# Access Compliance Report

## Public Rights-of-Way

### (Curb Ramps)

Intersection ID: 10023914	Main Street: CONFERENCE_DR	Cross Street: N/A	Location: NE
ADA ID: 57410D8B9CA1	Ramp Type: Perp	Initial Pass/Fail: Pass	Overall Compliance: No
Severity Score: 0			
Codes/Mitigation Info/Possible Solution		Field Measurements/Component Compliance

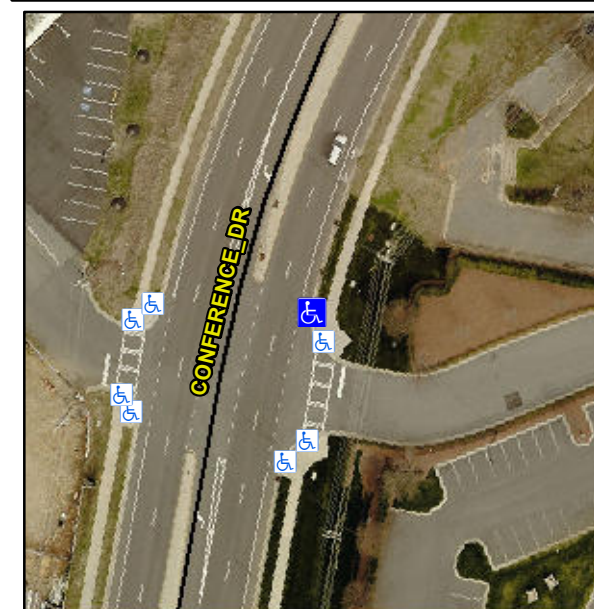
**Remove & Replace Entire Ramp.**

**R304.2.2-Perp, R304.3.2-Para, R305.2**
